RAI 02.04.04-9, Supplement 1, Part A:

The following changes will be made to COLA, Part 2, Tier 1, Section 5.0, Tier 2 Subsections 2.0, 2.4S.1, 2.4S.2, 2.4S.4, 2.4S.6, 2.4S.10, 2.4S.14, 2.5S.5, 3.4, and 3H, and COLA Part 7, Subsection 2.1, to incorporate the revised main cooling reservoir (MCR) embankment breach analysis as described in the responses to RAI questions 02.04.04-9 and 02.04.04-10.

Supplement 1, Part B, to RAI 02.04.04-9 Response:

Figure 2.4S.4-21(e): Time-Dependent Velocities Associated with East Breach Scenario

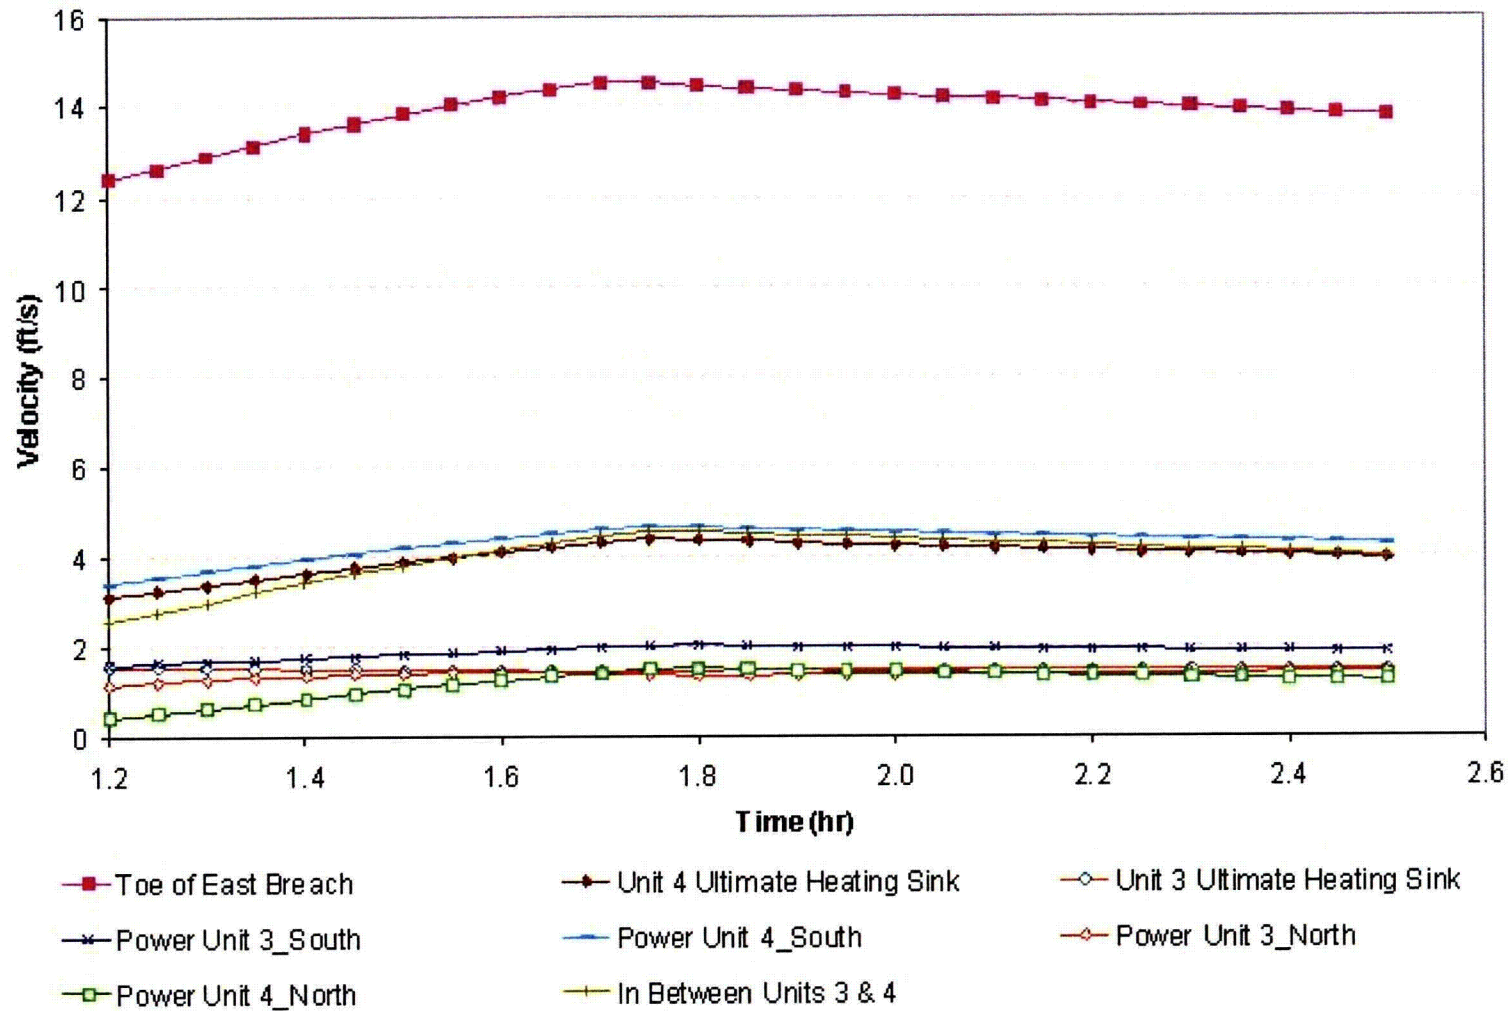
COLA Tier 2 Figure 2.4S.4-21(e) is a new figure:

Figure 2.4S.4-21(g): Velocities and Sediment Concentrations In Between Units 3 and 4 with East Breach Scenario

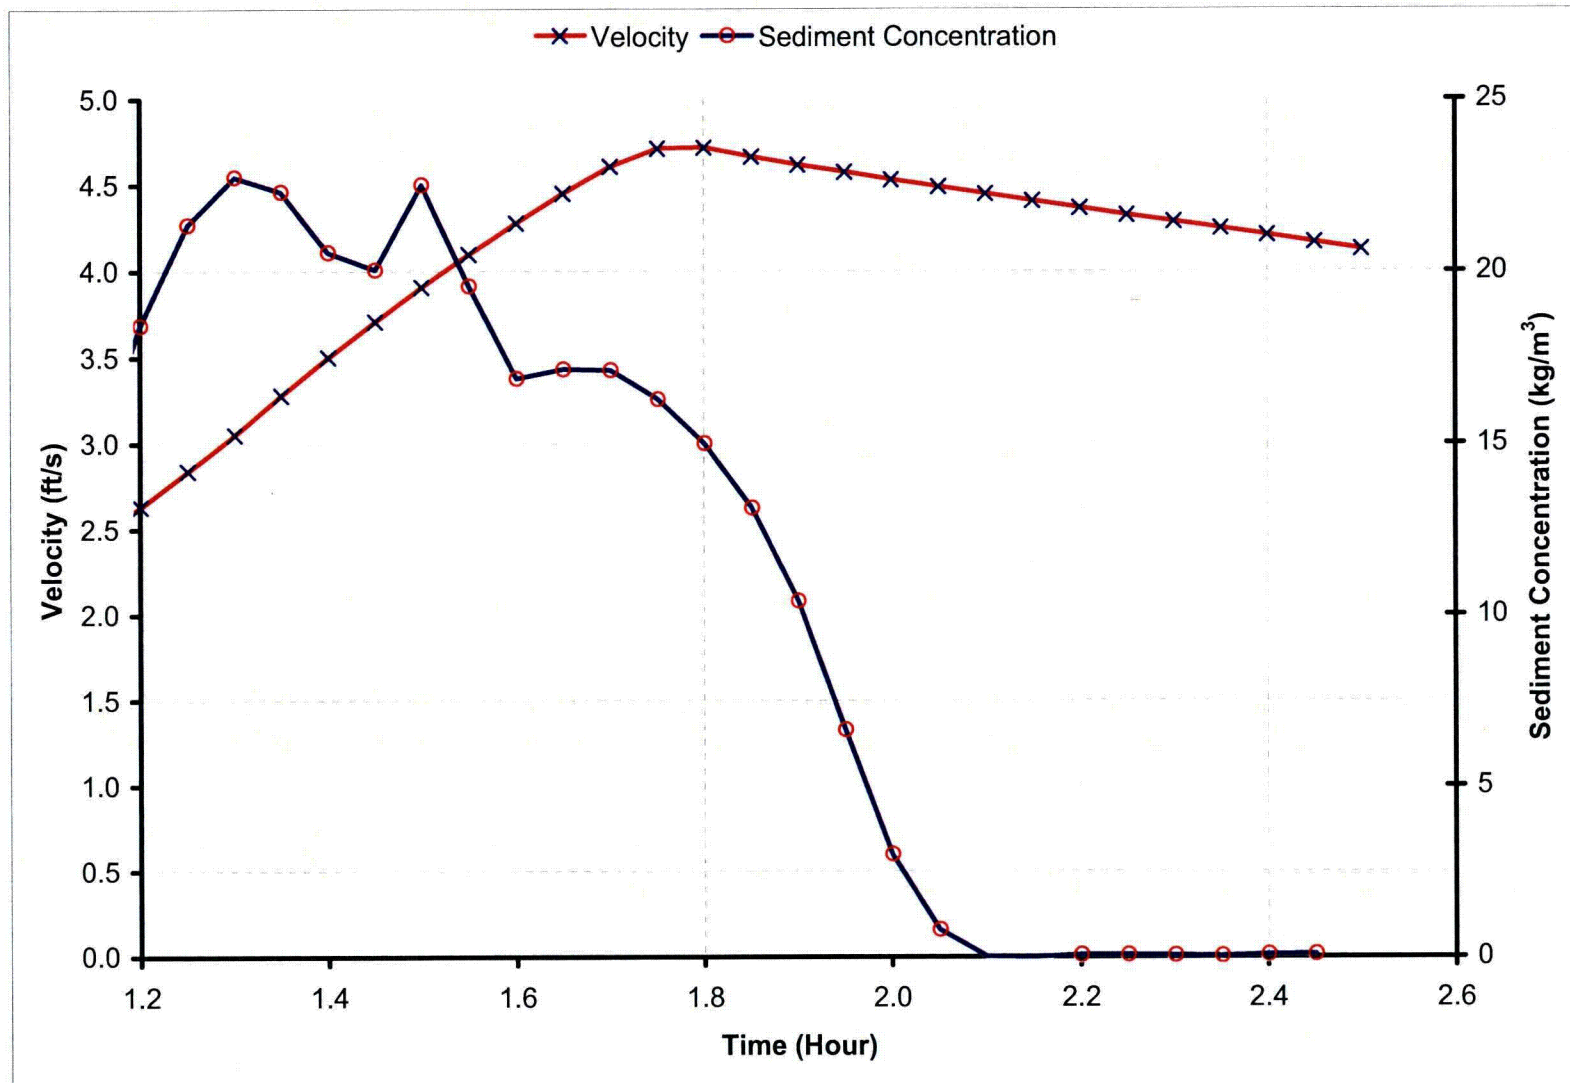
The maximum water levels and velocities obtained near Units 3 and 4 were used to assess the hydrodynamic loadings on the plant buildings. Figures 2.4S.4-21(g) and 2.4S.4-21(h) show the time-dependent plots of the velocities at this location during the east and west breach scenarios, respectively. The peak velocities observed were 4.72 and 4.68 feet per second for the east and west breach scenarios, respectively. Figures 2.4S.4-21(g) and 2.4S.4-21(h) also show the sediment concentrations predicted by the SED2D model. The sediment-laden water density was used for hydrodynamic load calculations. The figures show that the sediment concentrations at the time and location of peak velocities would be 16.5 kg/m³ and 15 kg/m³ for the east

and west breach scenarios, respectively. However, Figure 2.4S.4-21(g) shows a maximum concentration of 23 kg/m³ occurring at approximately T = 1.3 hours. Conservatively, the maximum sediment concentration was used in conjunction with the maximum velocity to determine the hydrodynamic loads on the STP 3 and 4 plant facilities. Selecting a 23 kg/m³ sediment concentration, a water density of 1023 kg/m³ or 63.85 lb/ft³ was used for load calculations. The maximum hydrostatic force on any plant building would be due to the depth of floodwater at the maximum water level. Hydrodynamic loads were calculated using the drag force formula with a drag coefficient conservatively set to 2.0, as presented below:

COLA Tier 2 Figure 2.4S.4-21(g) is a new figure:

Figure 2.4S.4-21(h): Velocities and Sediment Concentrations In Between Units 3 and 4 with West Breach Scenario

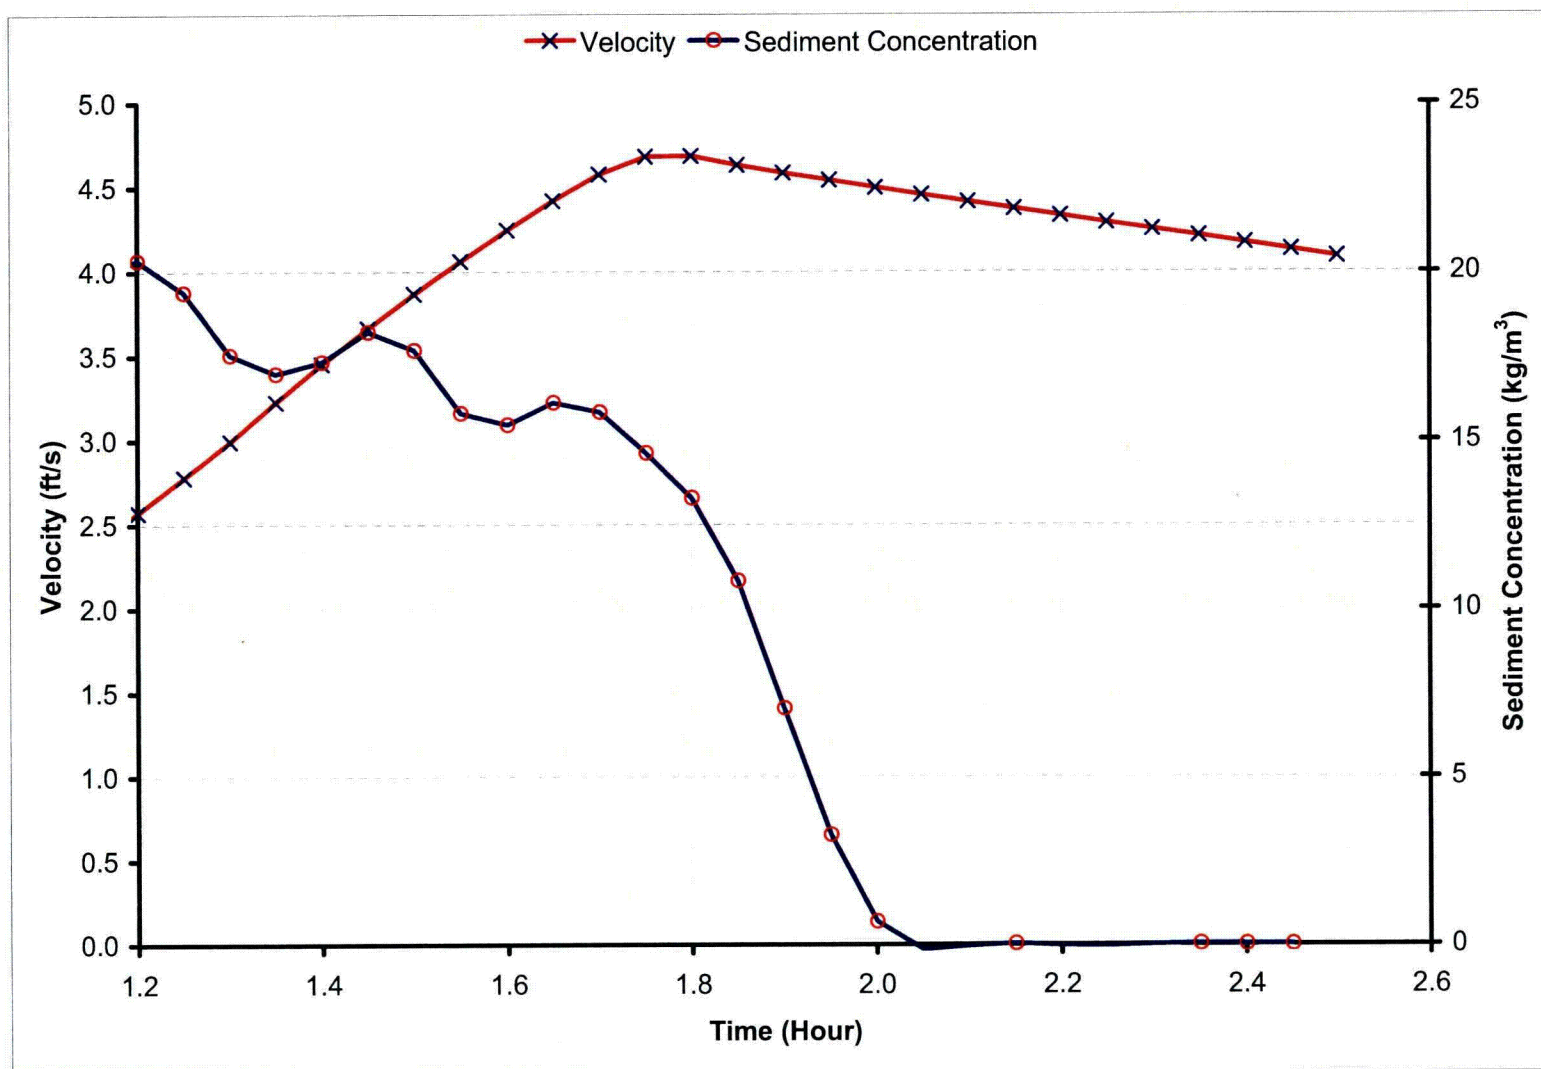
COLA Tier 2 Figure 2.4S.4-21(h) is a new figure:

Figure 2.4S.4-21(i): Stream System around STP Site

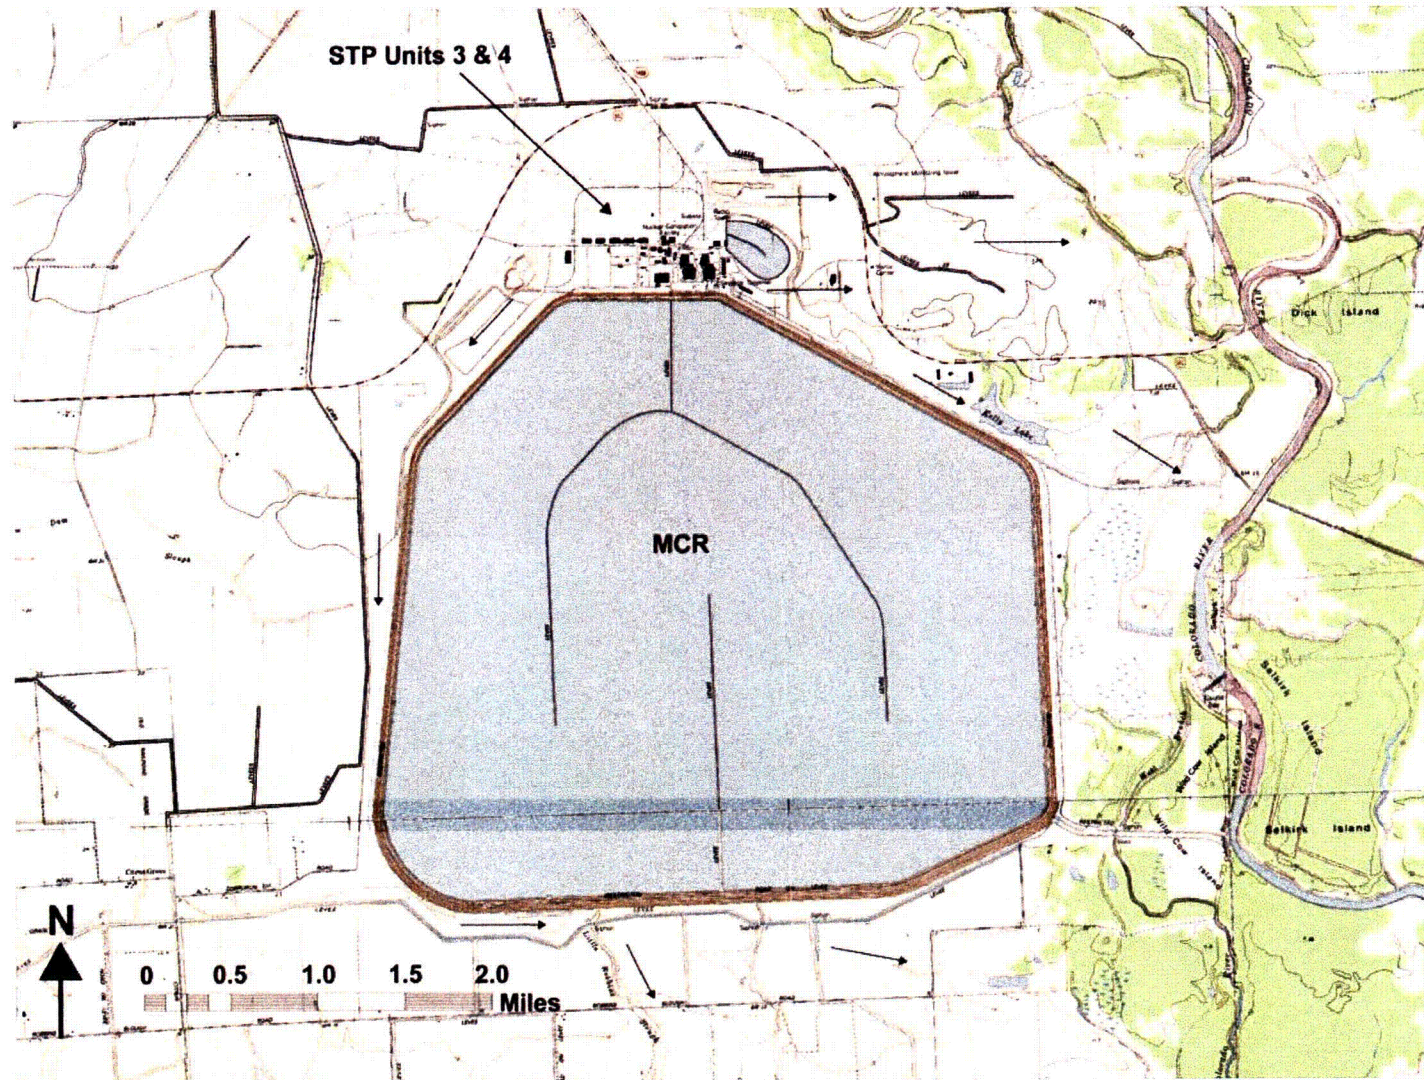
COLA Tier 2 Figure 2.4S.4-21(i) is a new figure:

Figure 2.5S.4-4 Subsurface Profile Plan

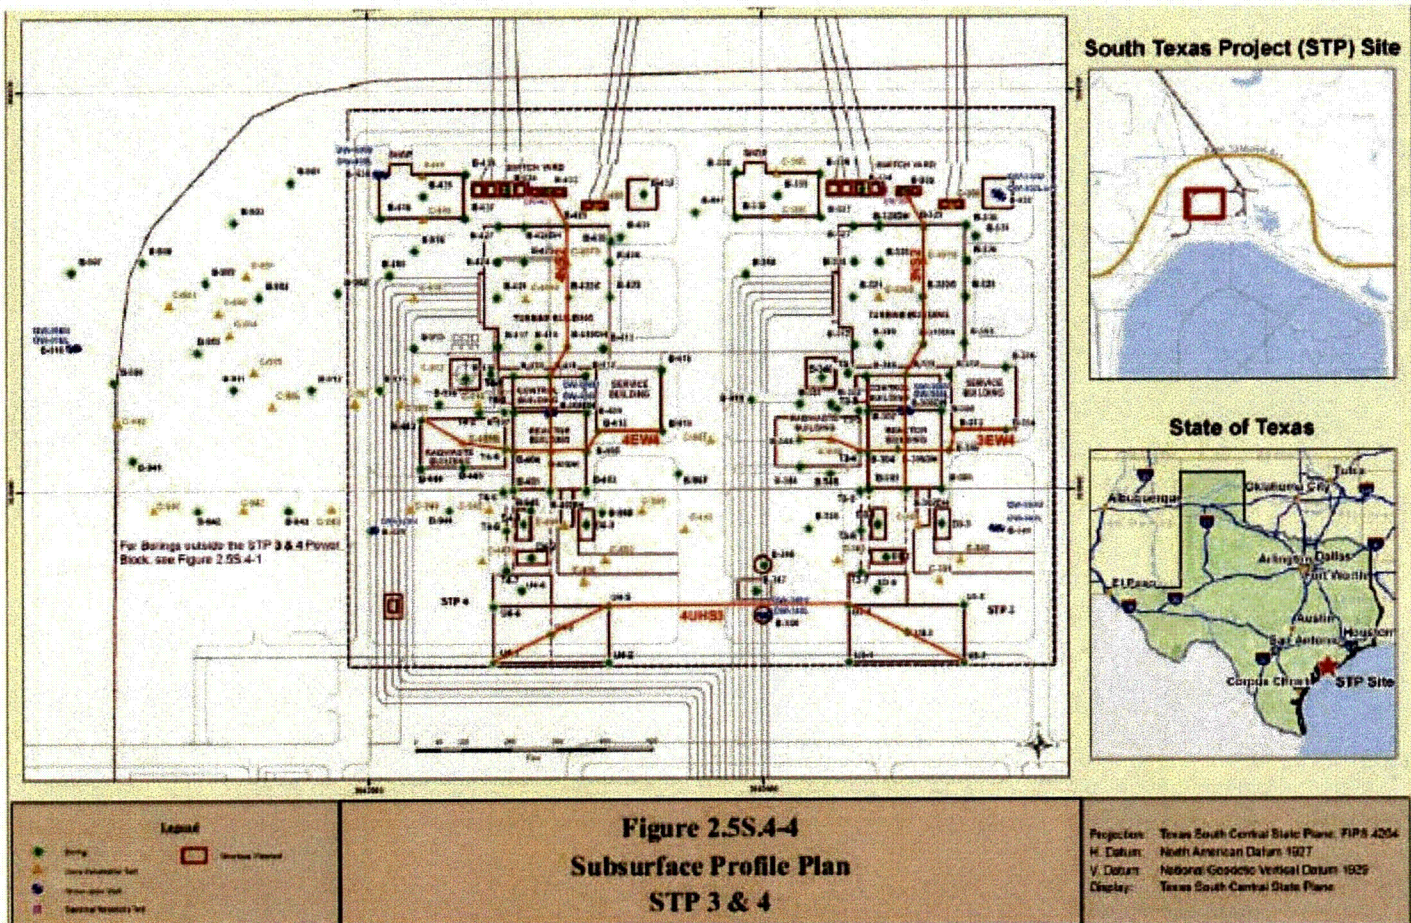
Figures 2.5S.4-2, 2.5S.4-4, 2.5S.4-5, 2.5S.4-7, and 2.5S.4-9 have been revised based on the relevant boring information from this investigation.
